SWIM PROJECT PROFILE

SWIM PROJECT PROFILE		File No. : 1
Regist. No. : Agency No. : DPWH-1	Name: SAYTAN DAM & RESERVOIR SWIP	
Region: 1	Province: LA UNION	Municipality: SAYTAN, PUGO
Present Status: 1. Pre-F/S() ② F/S(1983) ③ D/D(-)		
Purpose: Major : Irrigation Incidental : IF, FG, MH		
Project Feature:

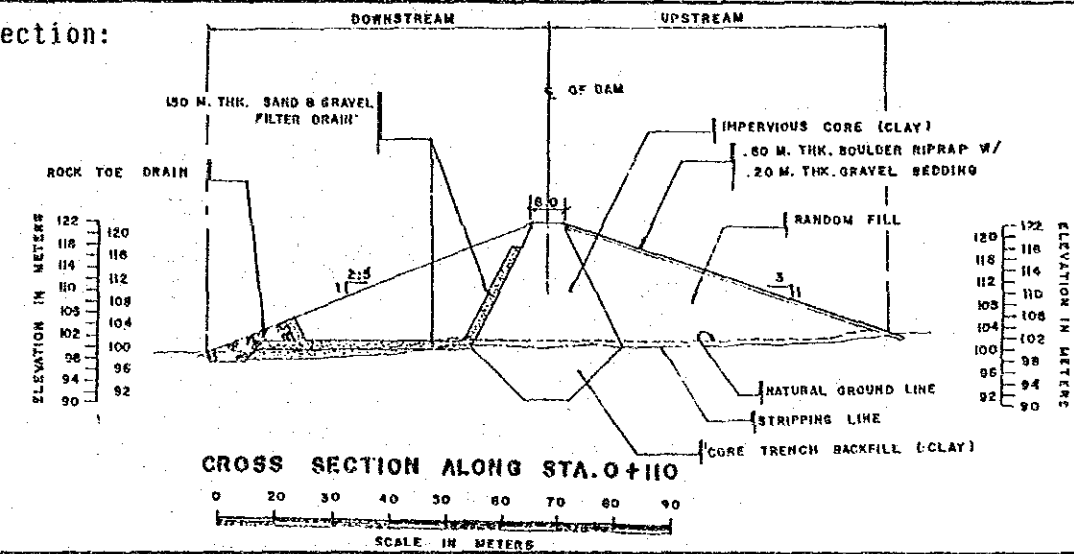
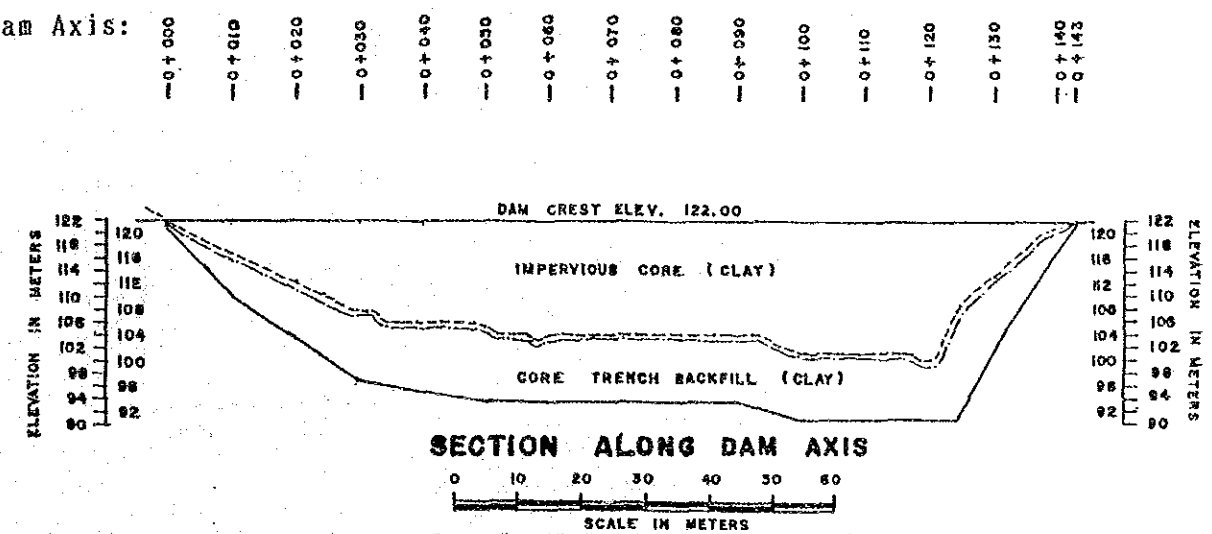
Dam type might be refined through the investigation on materials. Form and depth of core trench shall be decided after sub-surface geological study. If pervious layer is deep, impervious blanket instead of core trench is planned in the upstream.

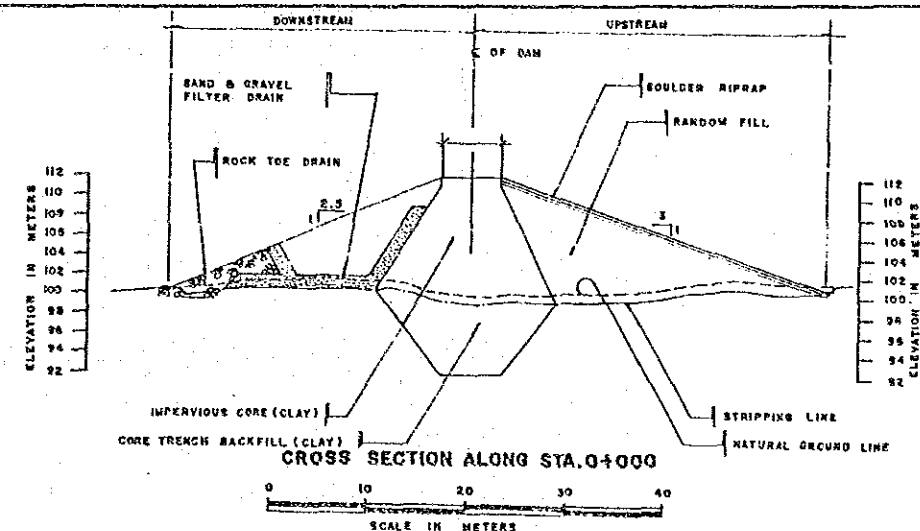
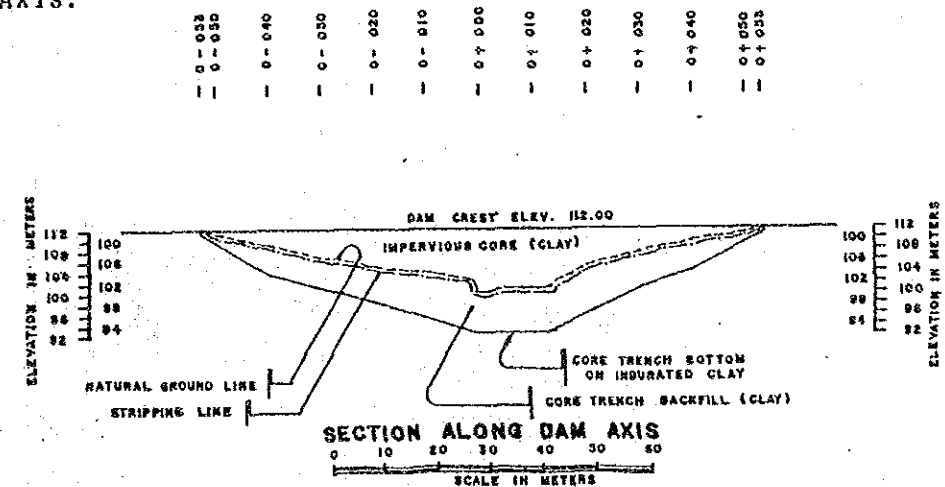
Dam type might be refined through the investigation on materials. Form and depth of core trench shall be decided after sub-surface geological study. If pervious layer is deep, impervious blanket instead of core trench is planned in the upstream.

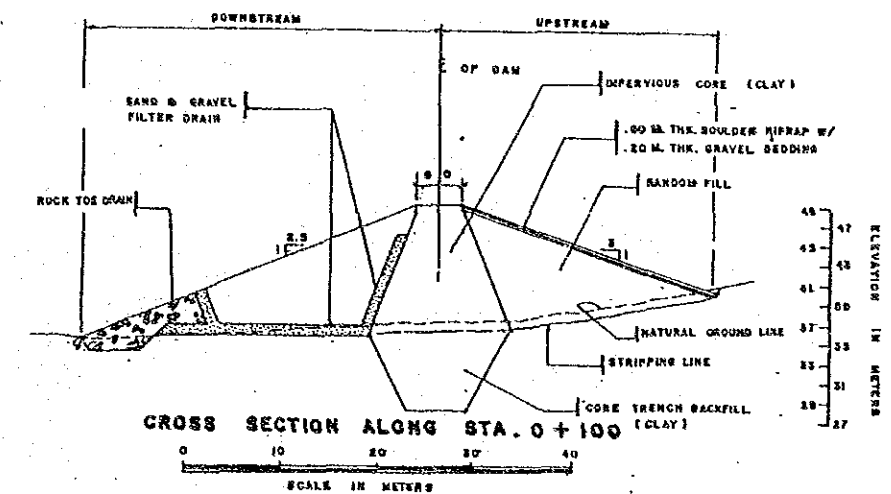
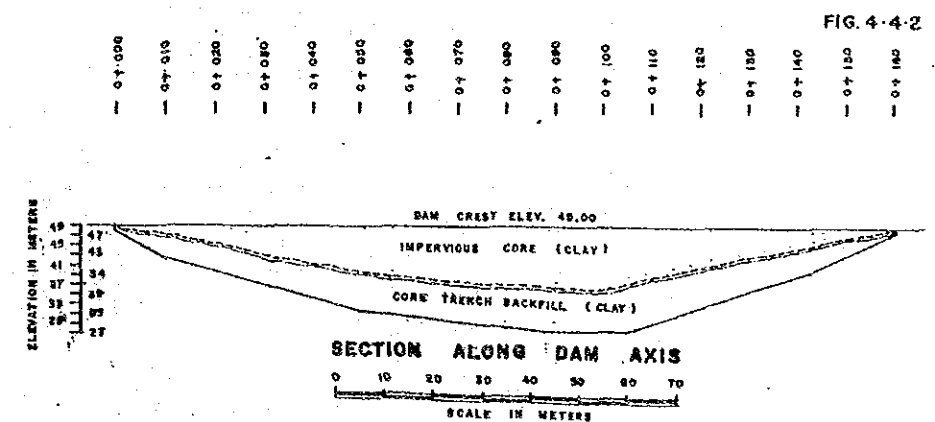
Dam type might be refined through the investigation on materials. Form and depth of core trench shall be decided after sub-surface geological study. If pervious layer is deep, impervious blanket instead of core trench is planned in the upstream.

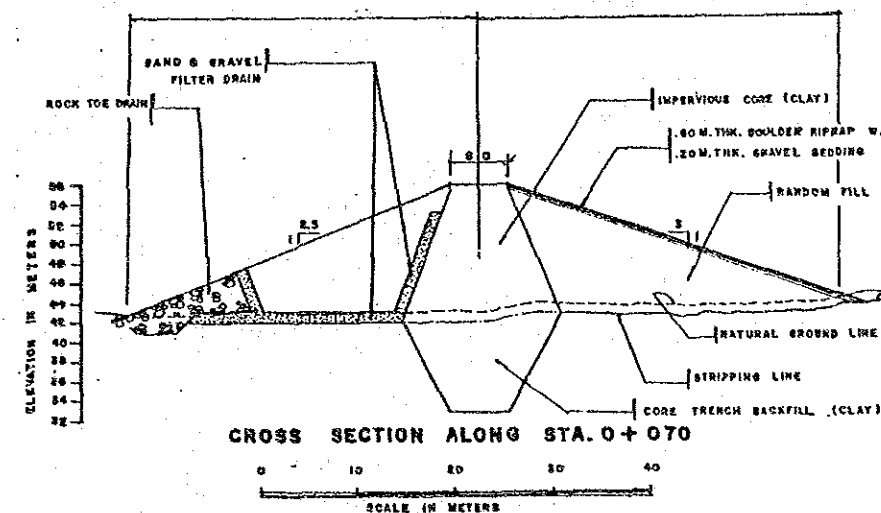
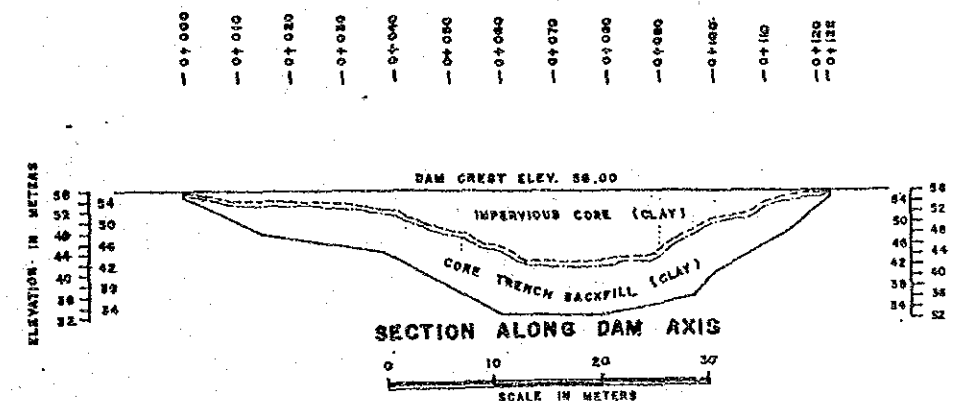
Dam type might be refined through the investigation on materials. Form and depth of core trench shall be decided after sub-surface geological study. If pervious layer is deep, impervious blanket instead of core trench is planned in the upstream.

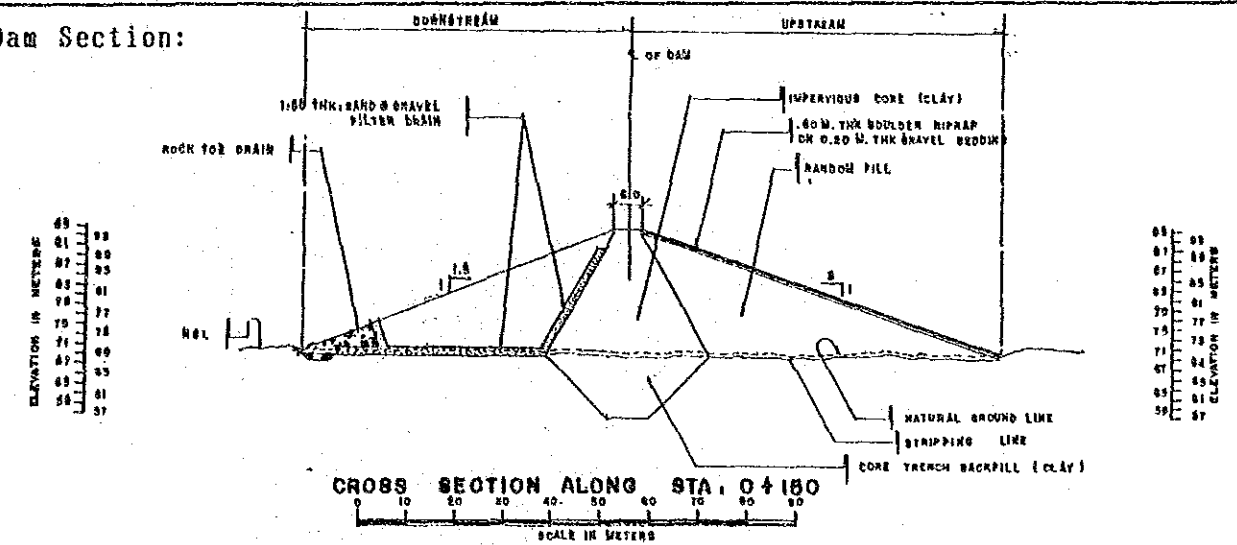
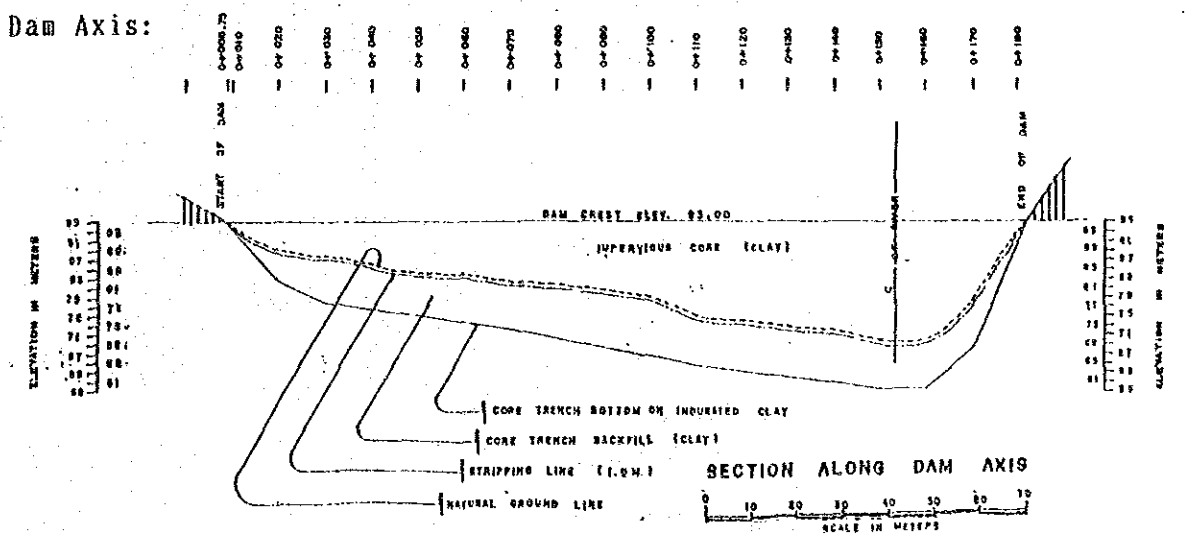
Note: Dam type might be refined through the investigation on materials. Form and depth of core trench shall be decided after sub-surface geological study. If pervious layer is deep, impervious blanket instead of core trench is planned in the upstream.

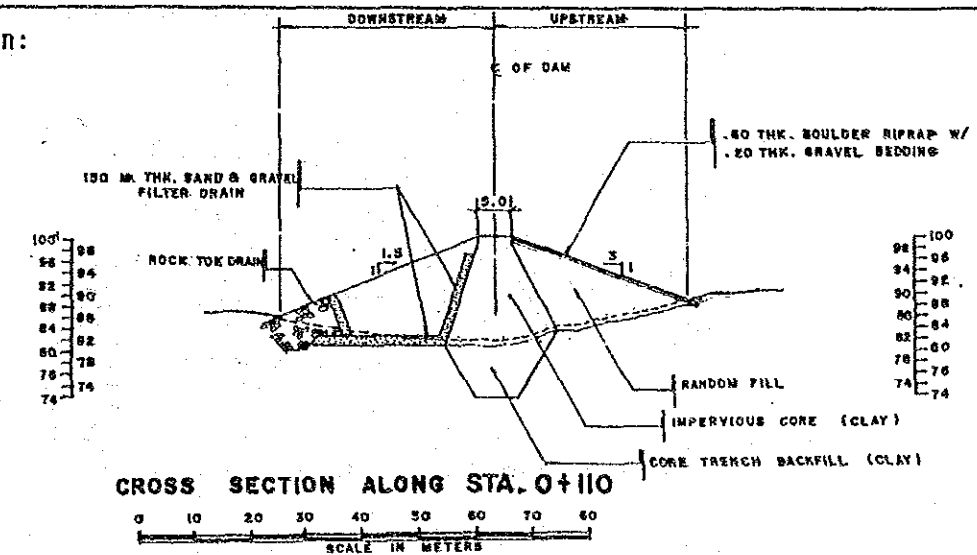
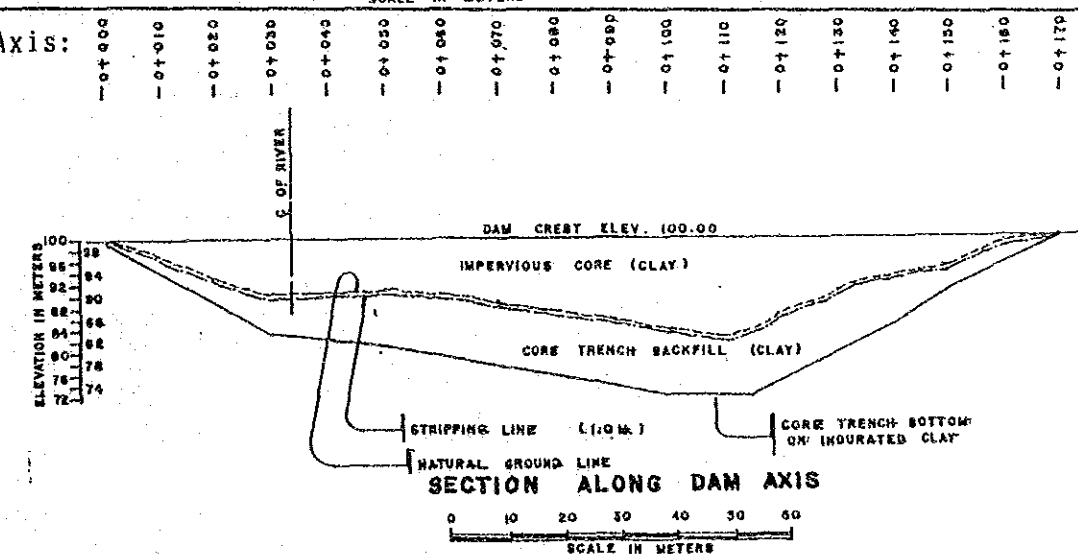
Dam type might be refined through the investigation on materials. Form and depth of core trench shall be decided after sub-surface geological study. If pervious layer is deep, impervious blanket instead of core trench is planned in the upstream.

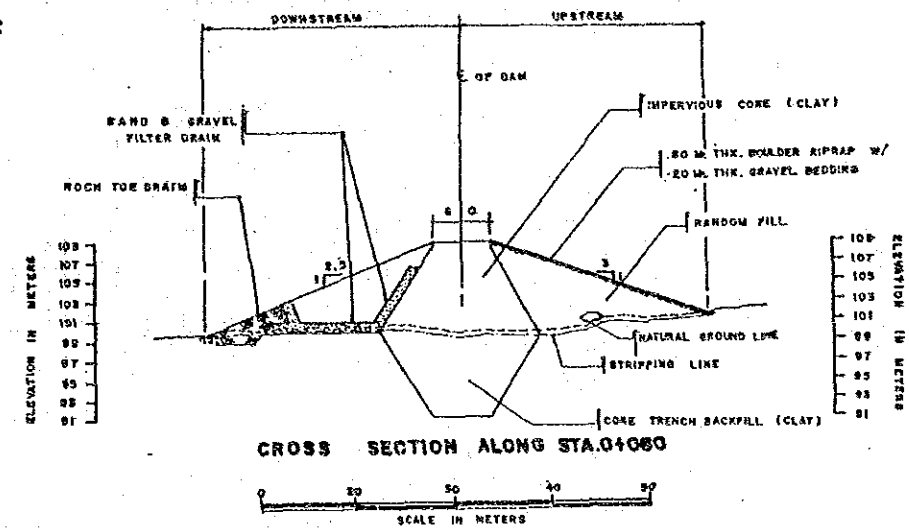
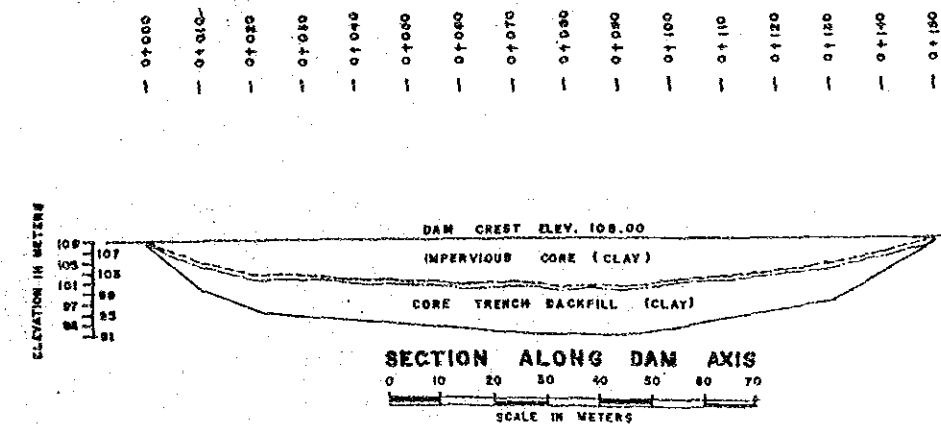
Dam type might be refined through the investigation on materials. Form and depth of core trench shall be decided after sub-surface geological study. If pervious layer is deep, impervious blanket instead of core trench is planned in the upstream.

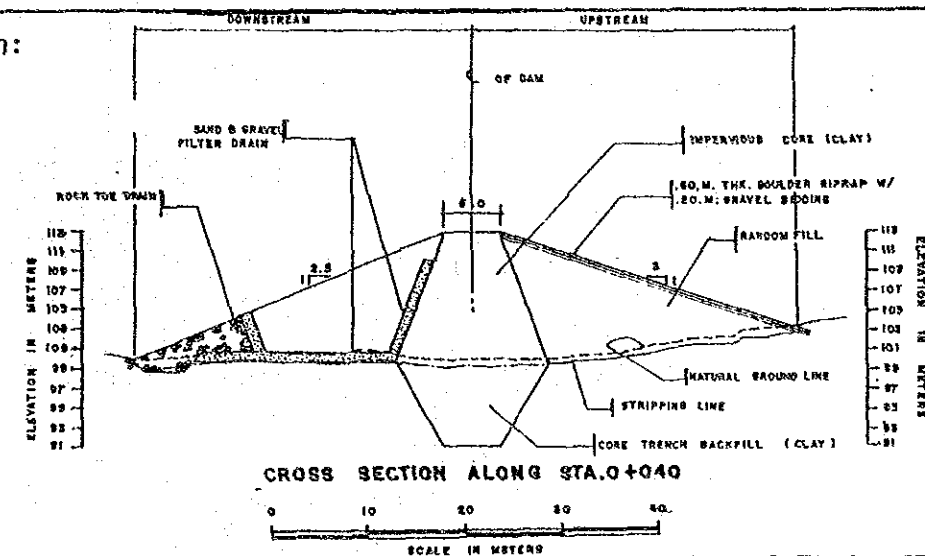
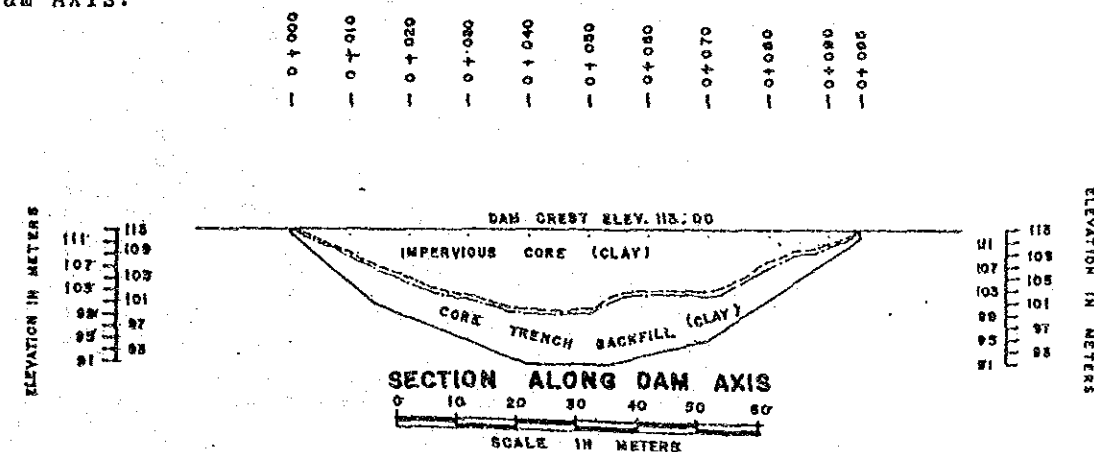
Dam type might be refined through the investigation on materials. Form and depth of core trench shall be decided after sub-surface geological study. If pervious layer is deep, impervious blanket instead of core trench is planned in the upstream.

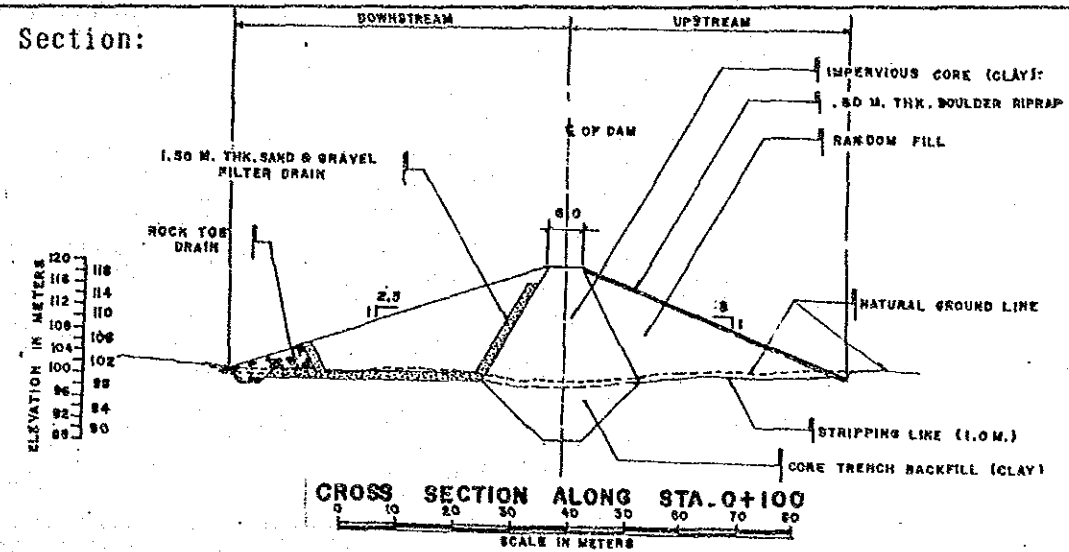
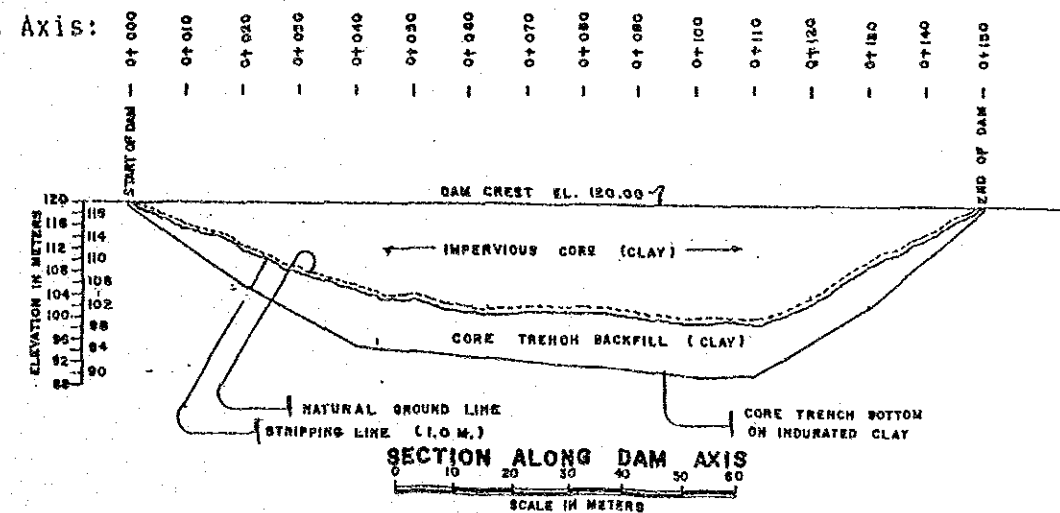
Dam type might be refined through the investigation on materials. Form and depth of core trench shall be decided after sub-surface geological study. If pervious layer is deep, impervious blanket instead of core trench is planned in the upstream.
